## **INTERROGATORY R317-6-2.1-27/03: GROUNDWATER MONITORING**

#### **INTERROGATORY STATEMENT:**

**Figure 1**  
**Location of Lost and Ant Knolls Springs and Tailings Storage Facility**

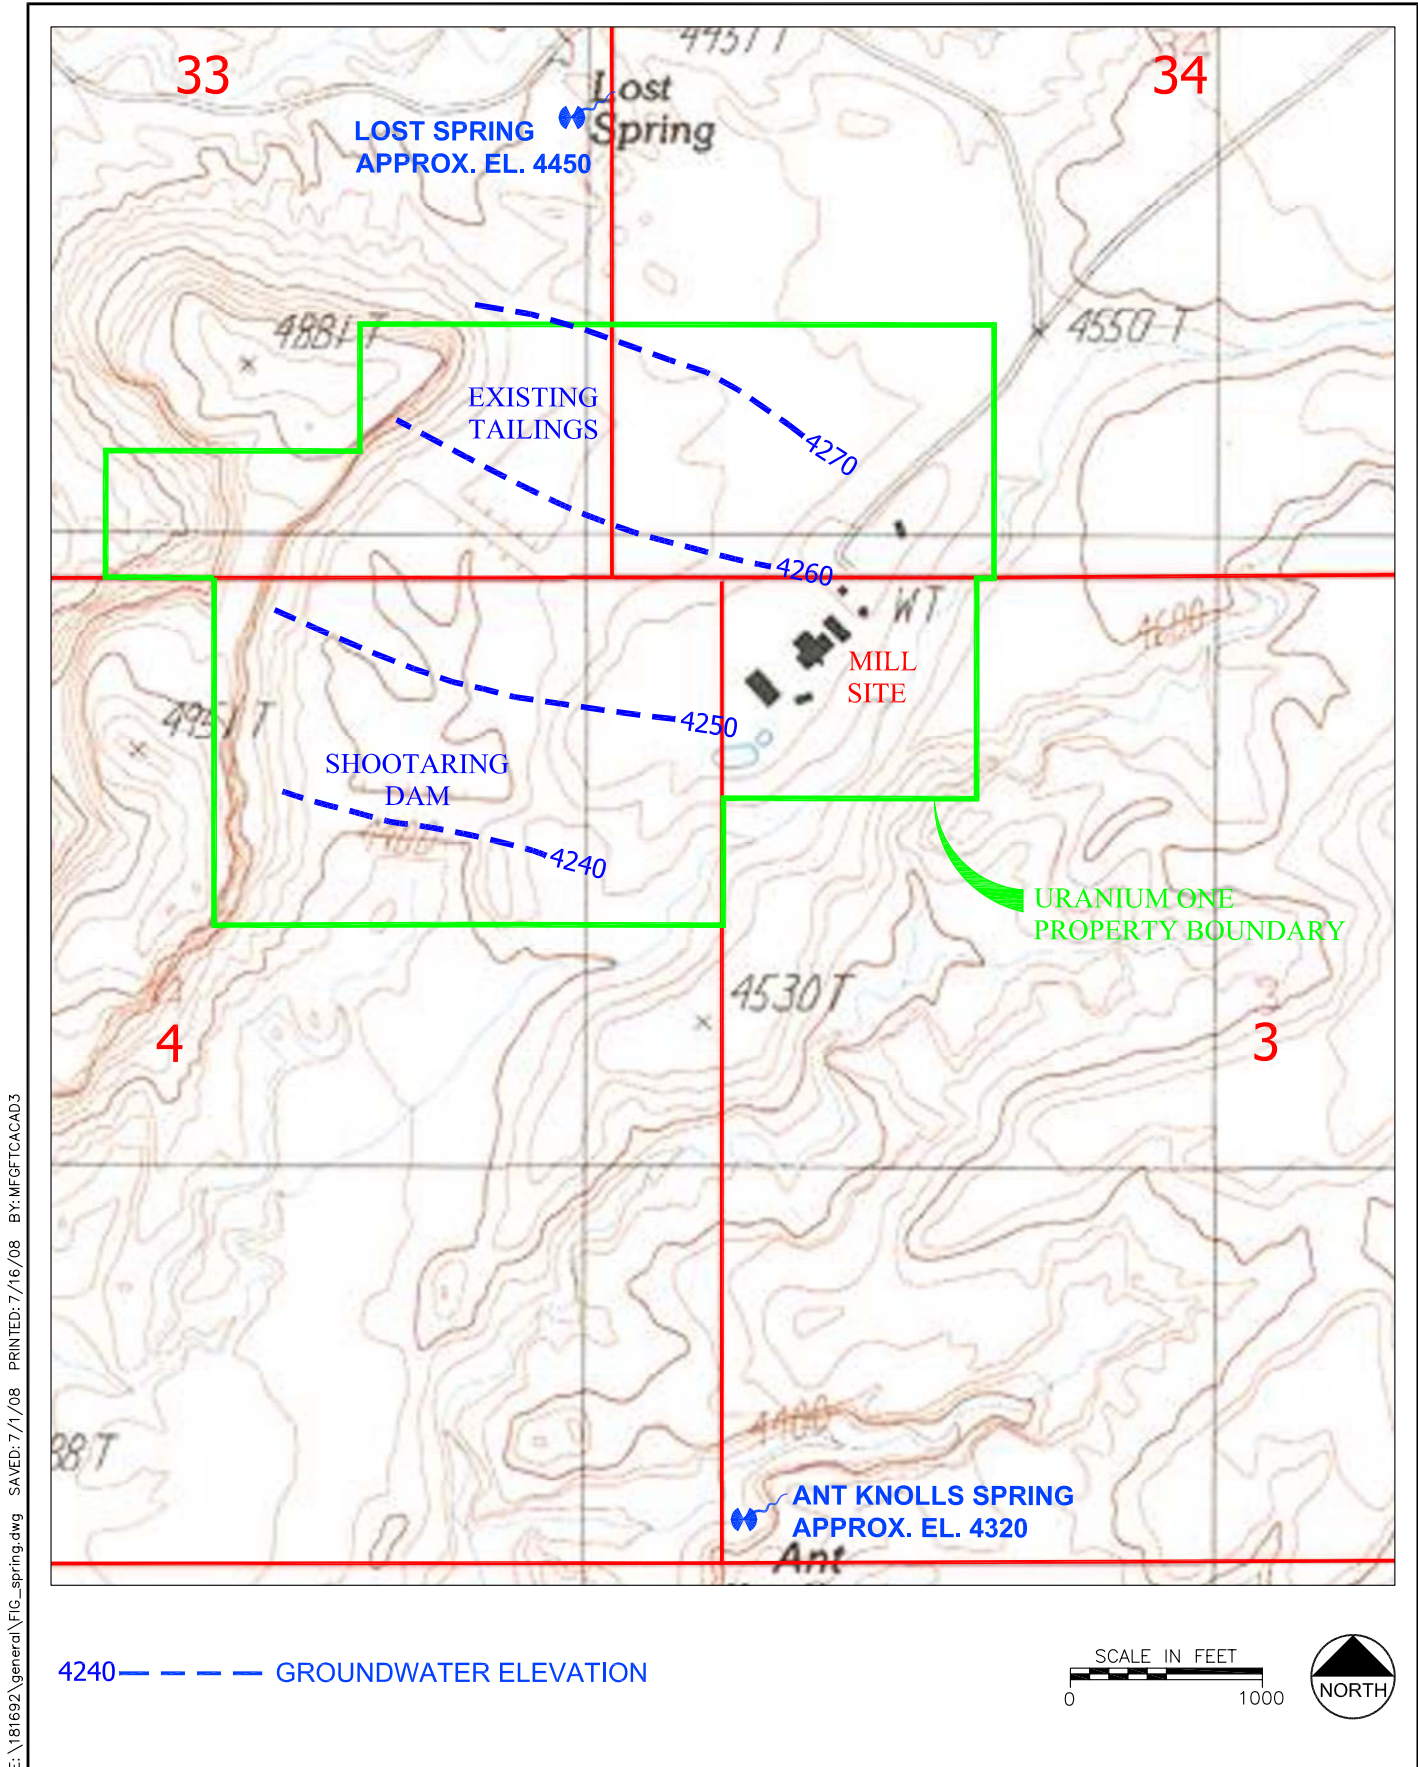
- a. *Please provide a proposed sampling and analysis plan for monitoring of the seep (or spring) located south of the mill site near Ant Knolls (as shown on Figure 1-1 of the revised Tailings Management Plan). Please also provide information to indicate whether sampling and analysis of springs or seeps located northwest of the mill site and proposed Cells 1 and 2 and the spring or seep located northeast of proposed Cells 1 and 2 (e.g. Lost Spring) would be conducted, for example, for comparison purposes. Alternatively, please provide justification for not monitoring these seep/spring locations.*

**Three springs around the site were investigated to determine if any relevant information could be determined by monitoring water quality from them. The three springs that were investigated are the Ant Knolls Spring, Lost Spring and a spring on Shitamaring Creek.**

**Ant Knolls Springs and Lost Springs are shown on Figure 1. Lost Springs is north and up-gradient from the proposed tailing disposal facility. Ant Knolls Spring is south and down-gradient from the tailings area. One additional seep**

was located northwest of the proposed disposal facility on Shitamaring Creek near its confluence with Lost Spring Wash. This seep is not shown on Figure 2 but exists at an approximate elevation of 4,330 feet above Mean Sea Level (MSL), and is approximately 4,000 feet northwest of the proposed tailings cells

Ant Knolls Spring is a small and discrete point seep down-gradient from the tailings area and exists at an elevation of 4320 feet MSL, approximately 80 feet higher than the elevation of the groundwater under the south end of the tailings disposal facility (approximate elevation of 4240 feet MSL). Therefore, the water in this spring cannot be hydraulically connected to the groundwater under the tailings and is likely from a localized perched zone well above the main Entrada aquifer.

The Lost Spring is also a small and discrete point seep up-gradient from the proposed site and is at an elevation of 4450 feet MSL, approximately 180 feet above the elevation of the groundwater under the north end of the tailings area (approximately 4270 feet MSL). Assuming the groundwater gradient is relatively uniform in the area as indicated by historical data which is reported in the annual groundwater monitoring reports, the groundwater elevation in the main Entrada formation in the Lost Spring area is projected to be approximately 4280 feet to 4290 feet MSL. The elevation of the spring is 4450 feet MSL which is approximately 170 feet above the estimated groundwater elevation in the Entrada at that location and therefore Lost Spring could not be hydraulically connected to the Entrada aquifer. It is likely that the water in this spring is also created by a localized perched zone well above the main Entrada aquifer.

The spring on Shitamaring Creek is upgradient from the site. It is unclear if the water in the spring is from the main Entrada formation or in a perched zone. If the water is from the main Entrada aquifer, it is not connected to the Entrada aquifer under the proposed tailings disposal facility as it is discharging to the surface as a result of an incised drainage system.

Since the springs are not isolated from potential contaminant transport flow paths, there is no reason to sample and monitor the seeps as they could not be impacted by potential future site ground water impacts or be useful in determining background water quality.
